Bike Anchorage Comment Re:
Safer Seward Highway Draft Environmental Assessment

1. Executive Summary

Figure 2-2. Fatal crash locations (2017–2021).

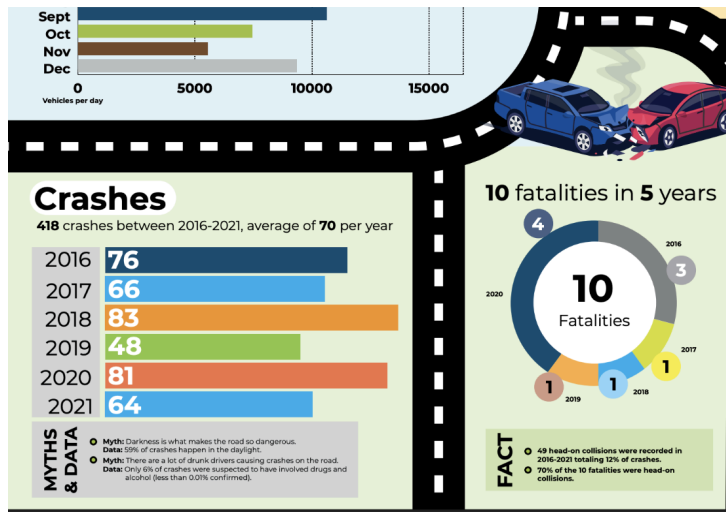
There is a serious issue with the crash data in Appendix G. The document states: “Four crashes within the Project corridor resulted in fatalities during the 5-year study period: two in 2018, one in 2019, and one in 2021 (Figure 2-2). Three of the fatalities were from head-on crashes that occurred between MPs 102 and 104.” Figure 2-2 plots these on a map and immediately contradicts the narrative, with four crashes listed with the dates 2018, 2019, 2020 and 2020.

For the purposes of our analysis in this document, we have assumed that the only error in this graphic is in the year listed for each crash, and that the other characteristics attributed to each crash are accurate. However, as you can imagine, the quality of the data provided by the project team constrains our analysis here as much as it determines the validity of the EA itself.

Figure 2-1. Crashes per year (2017–2021).

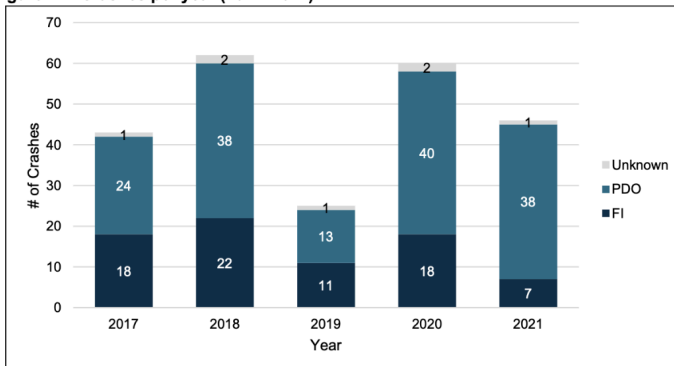
Finally, the draft EA makes clear that the data set is from 2017-2021, and presents a yearly breakdown of crashes that do not match up with those reported in the 2023 public presentation:

The 2023 slide deck claims an "average" of 70 crashes per year, but not a single year actually reported in the draft EA reaches that threshold. Which numbers are true and correct, and why were the others allowed to be released to the public?
